**LEGAL ADVERTISEMENT
HISTORIC PRESERVATION BOARD
CITY OF PORTLAND
Public comments are taken at all meetings.**

HISTORIC PRESERVATION BOARD AGENDA

**WORKSHOP
113 WINTER STREET**

RE: July 15, 2015 Preliminary review – rooftop dormer addition

113 WINTER ST.
PROPOSED SOUTH ELEVATION
~~1/4" = 1'0"~~ NTS

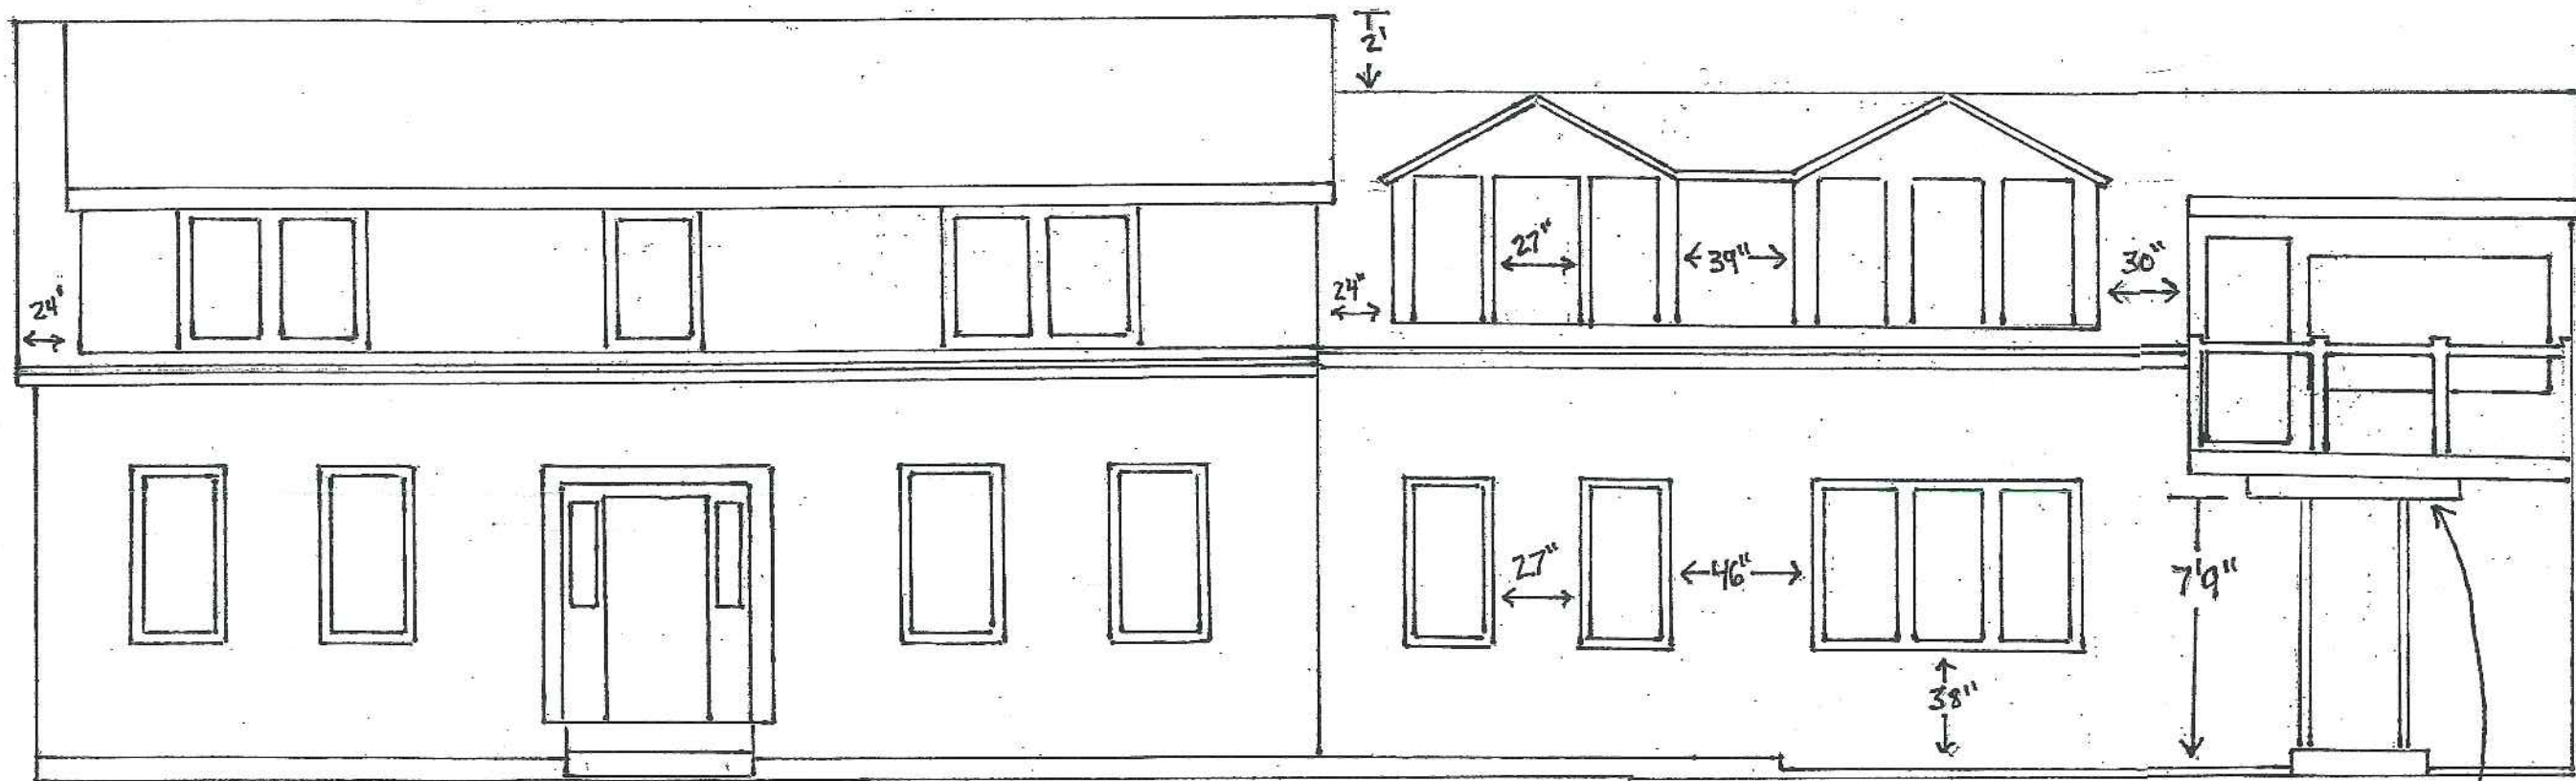
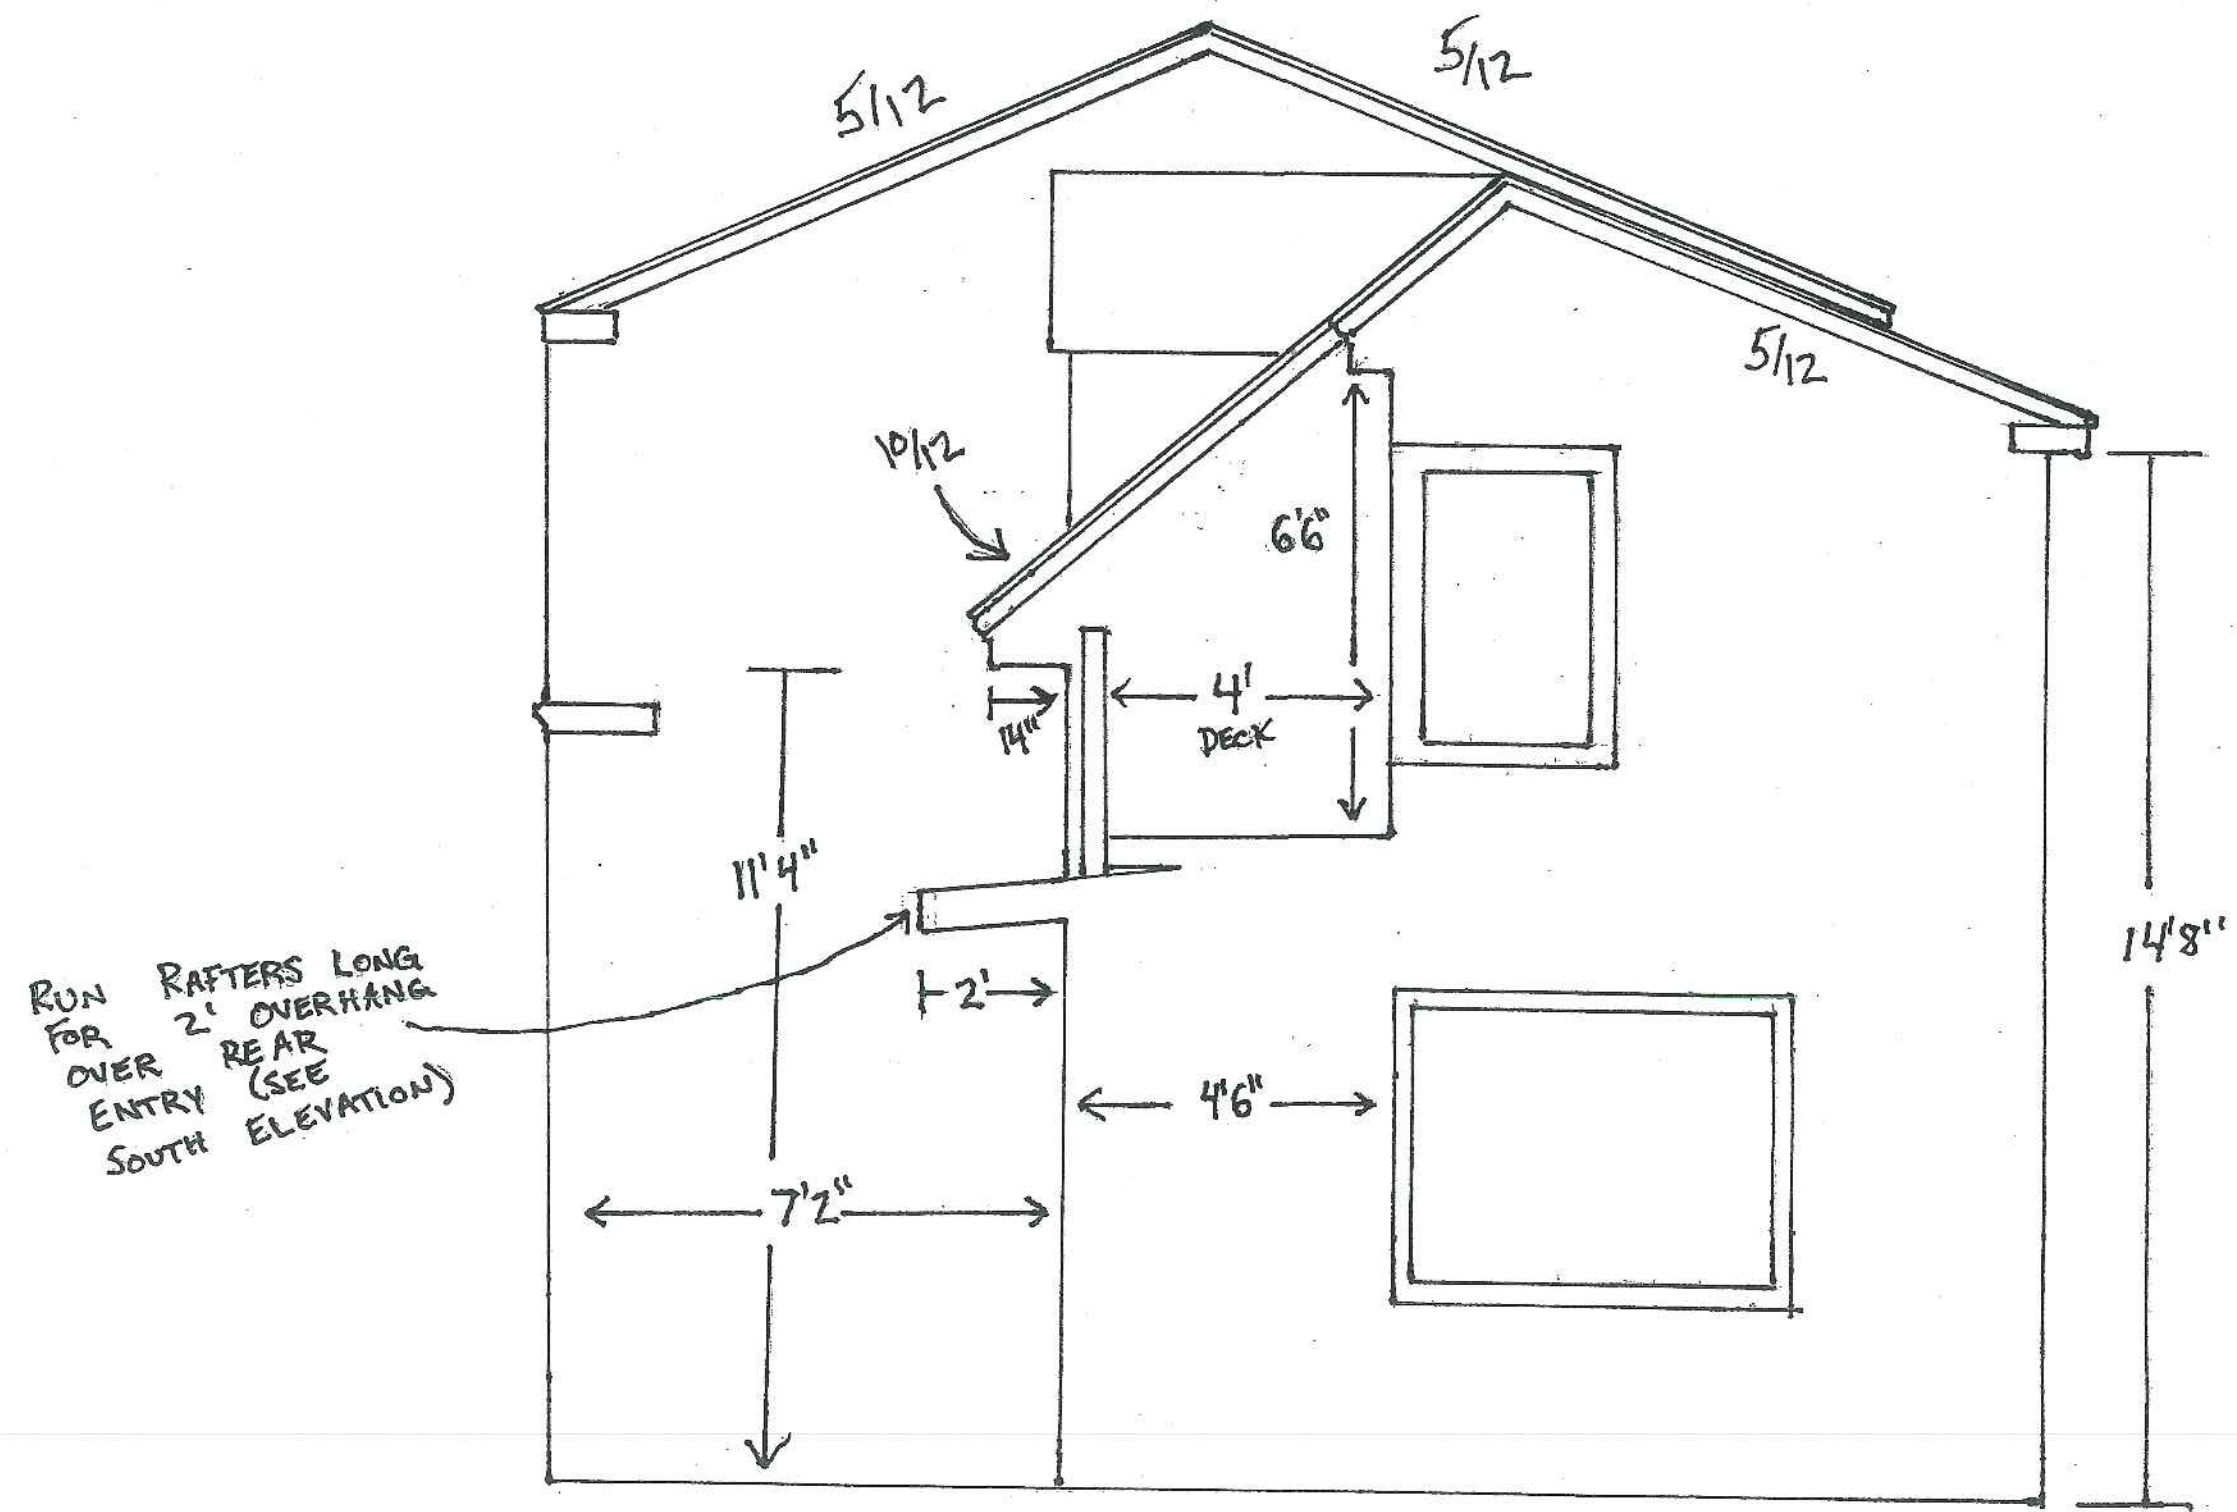
- Is the proposed shape of the new dormer, with two gabled units connected by a shed, too complex? Should a simple shed similar to the front dormers be used instead? Maximizing interior headroom is a goal in this design, and perhaps adding the two gables yields a more spacious result. There is not full visibility of the proposed expanded dormer, and the setback of the rear section may help avoid overwhelming the present form.

- Is the proposed fenestration, with three sets of triple mulled (presumably 6/6 double-hung) windows on the south face of the rear unit an acceptable configuration, or should the fenestration be more similar to the front building?

- Does cutting away the rear shed dormer to create a small second-story deck help the design by removing the dormer's bulk at the very end of the house? Is the re-introduced deck in this location a reasonably compatible feature – perhaps preferable to

113 WINTER ST.
PROPOSED REAR (EAST) ELEVATION
~~3/8" = 1'0"~~ NTS

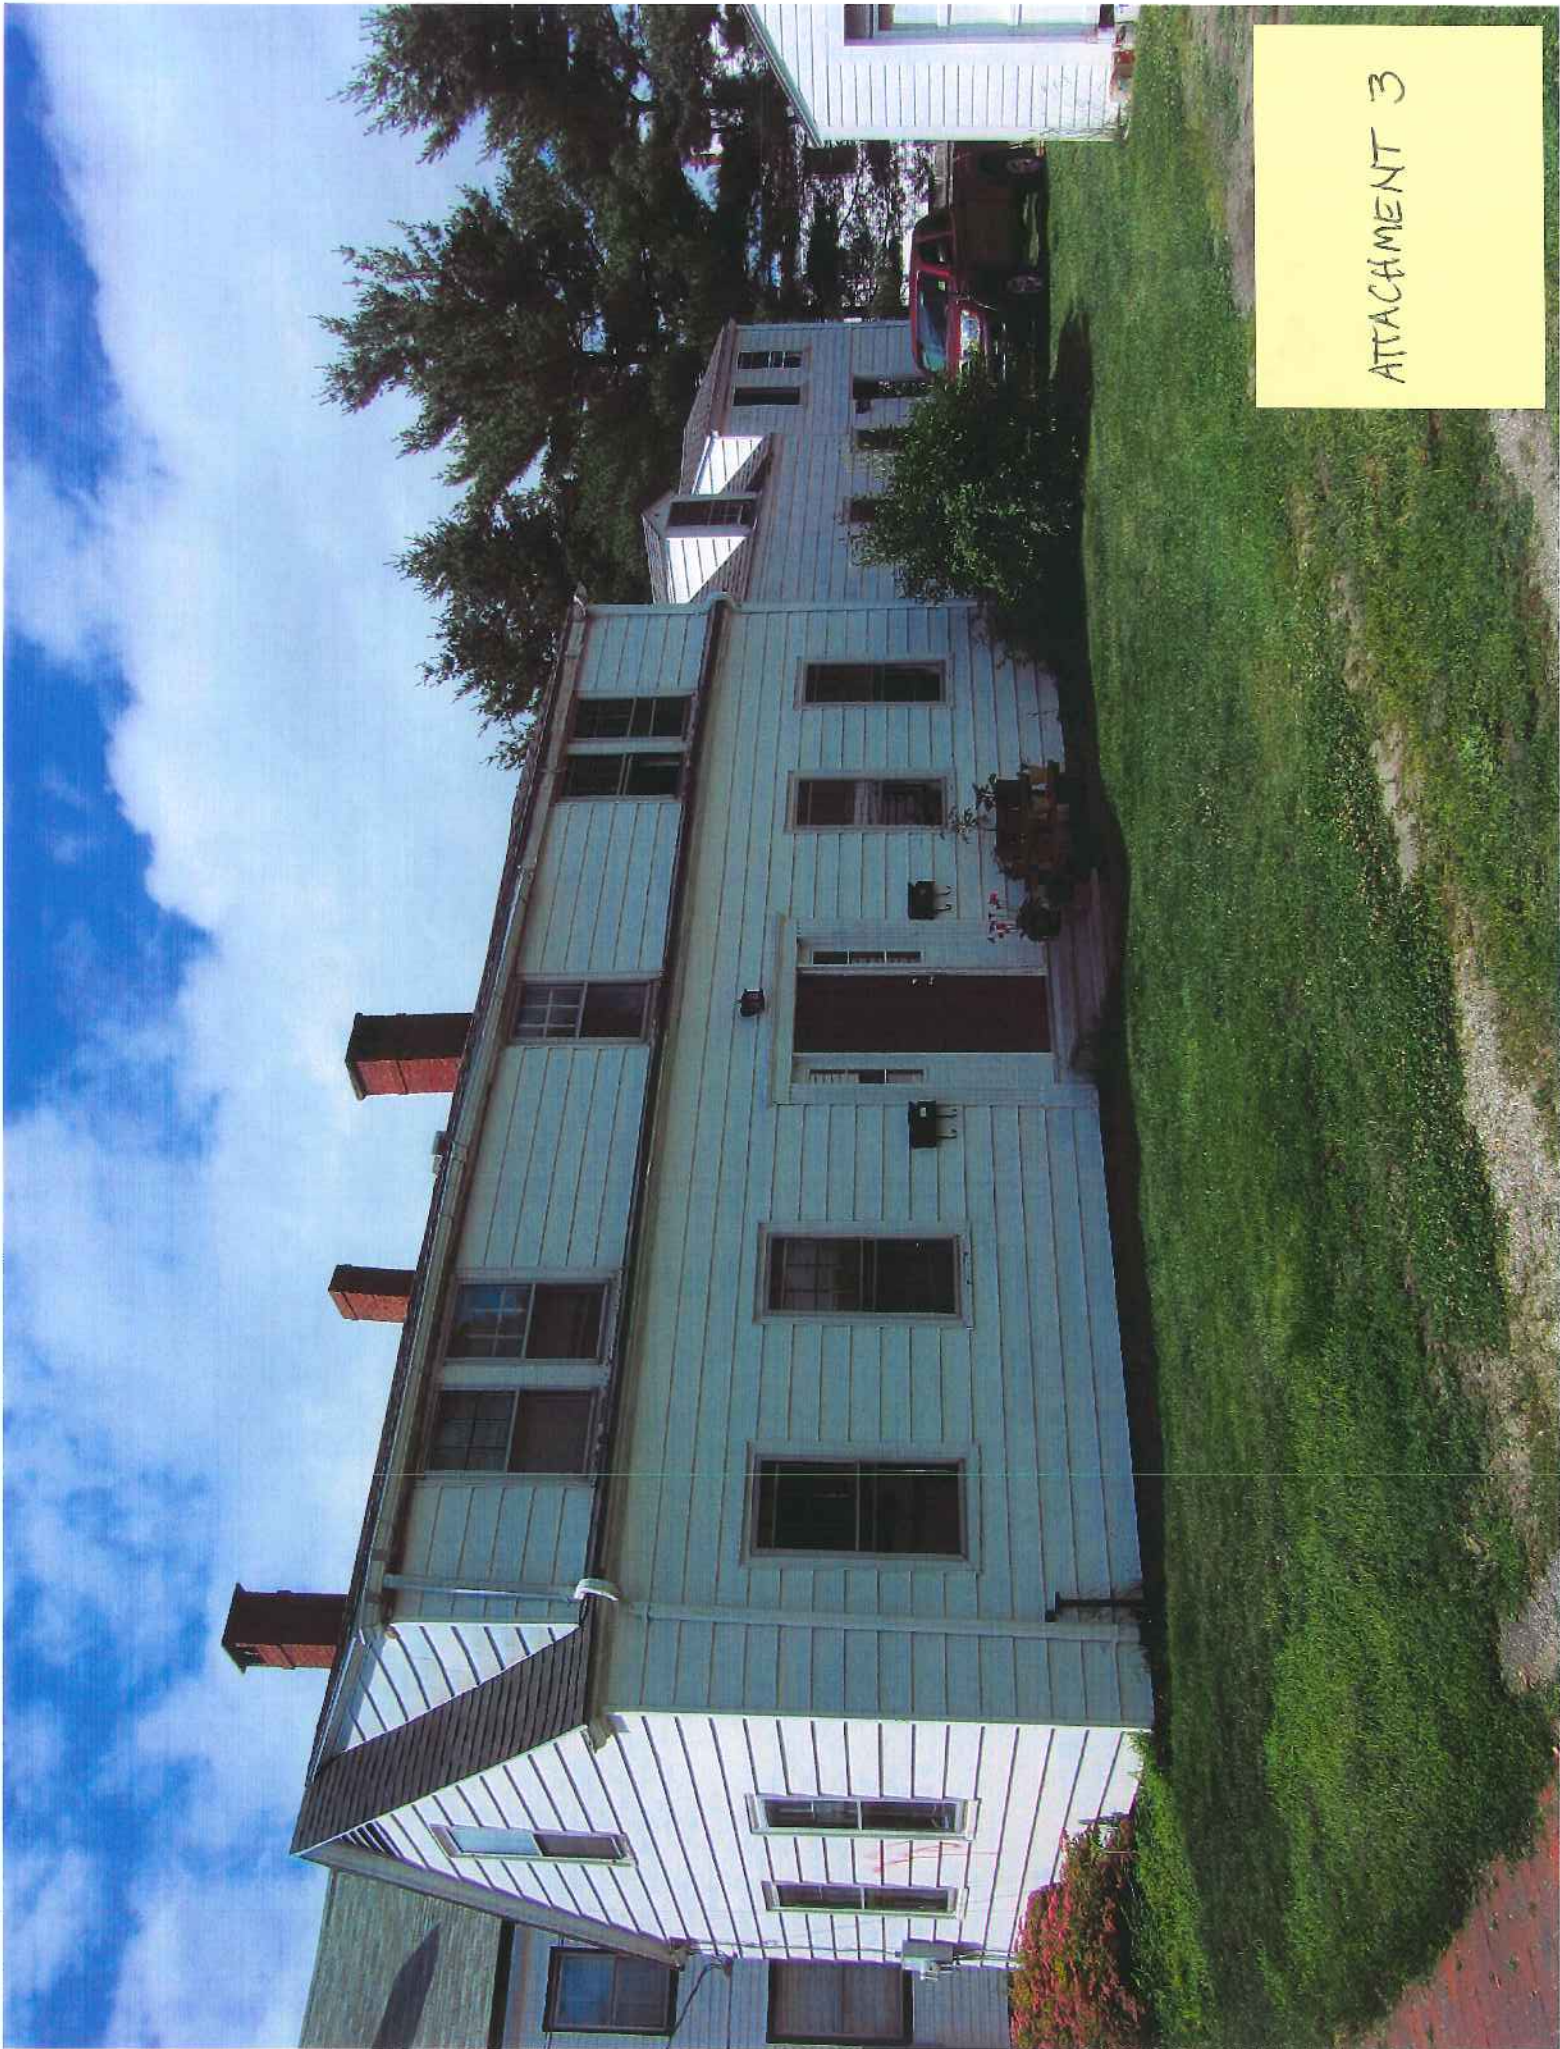
- As listed in Mr. White's proposed scope of work, he would like to increase opportunities for a ventilated roof and at the same time protect the sidewalls by slightly increasing overhangs. Would the Board judge the addition of a small cornice to be inappropriate? Should the applicants be encouraged to find a way to add ventilation without a wider overhang than is visible in the 1924 tax photo?
- Mr. White's narrative also poses a question about adding appropriate, simple hoods to shelter each of the two entrances.
